Architect's Supplemental Instructions

Architect's ASI No: 065

Project:
Webster University
Interdisciplinary Science
Building

ASI-065 is being issued for the purpose of providing DI/RO water connections for future laboratory equipment in Lab 291.

1 LEVEL 02 AREA A FLOOR PLAN - LABORATORY DEIONIZED WATER SYSTEM
1/8" = 1'-0"

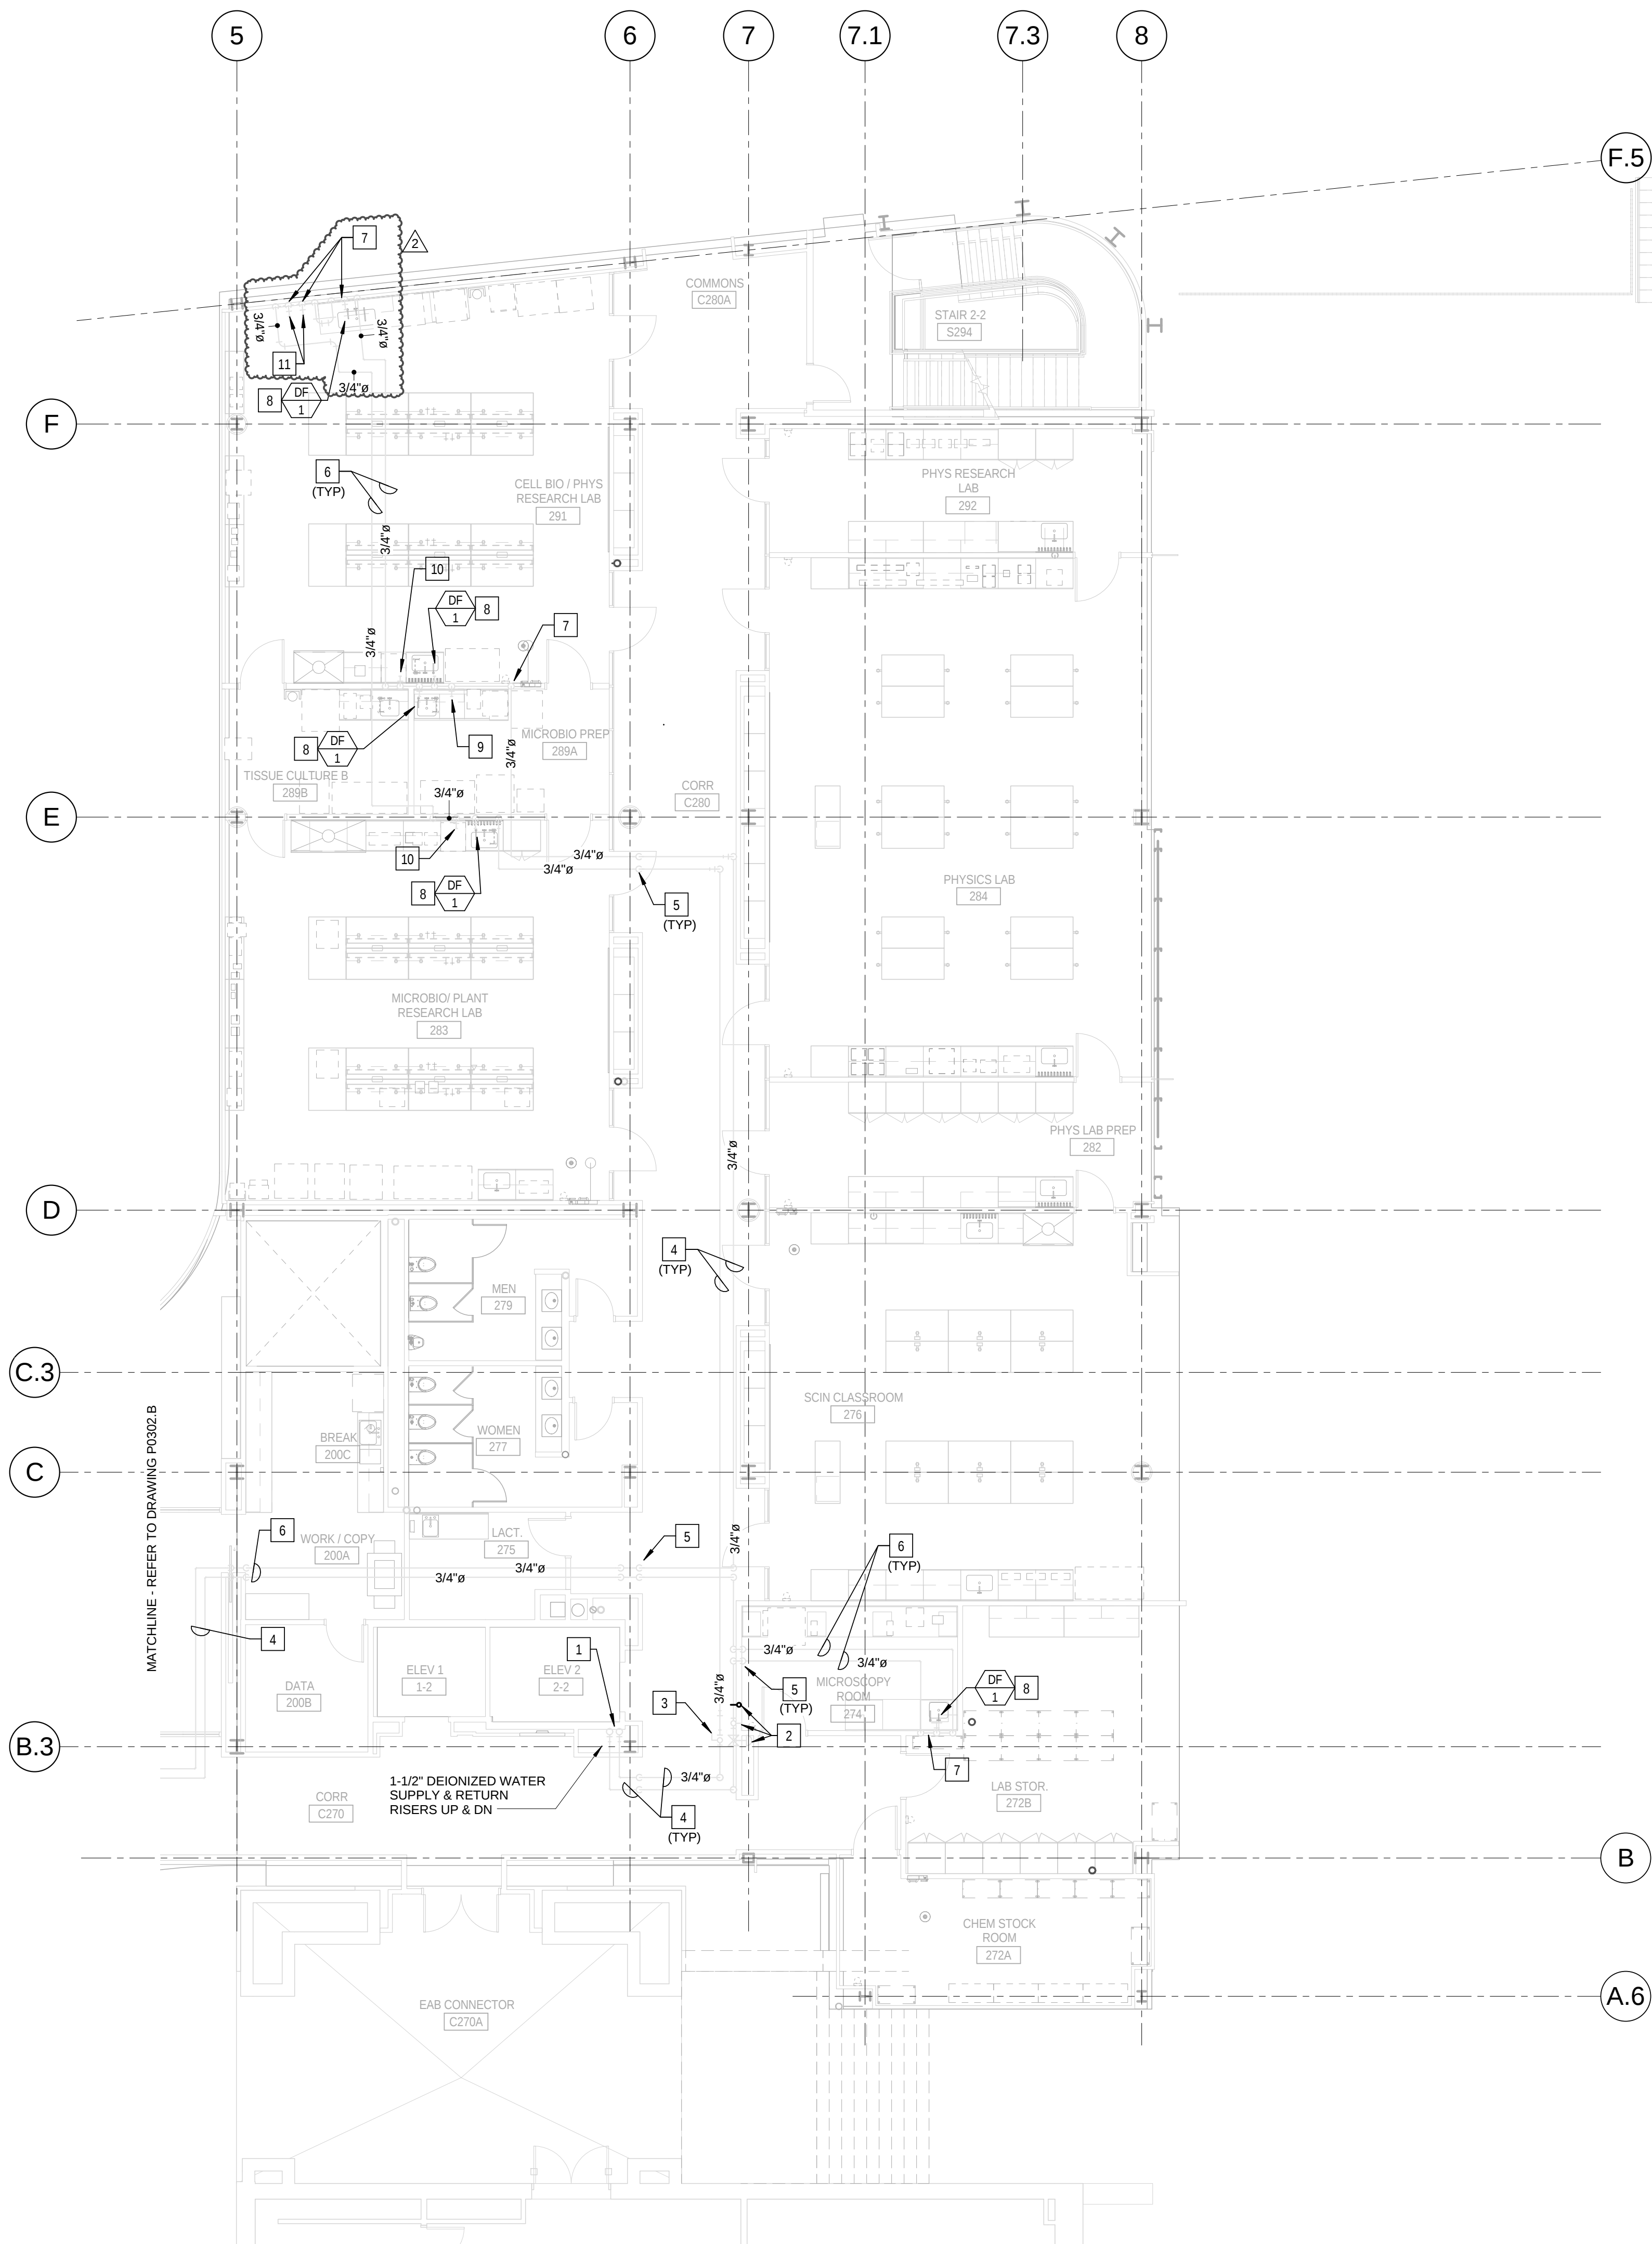
- PROVIDE BALL VALVE CONNECTION FOR FUTURE LAB EQUIPMENT. REFER TO DRAWING P0502, DETAIL 2.
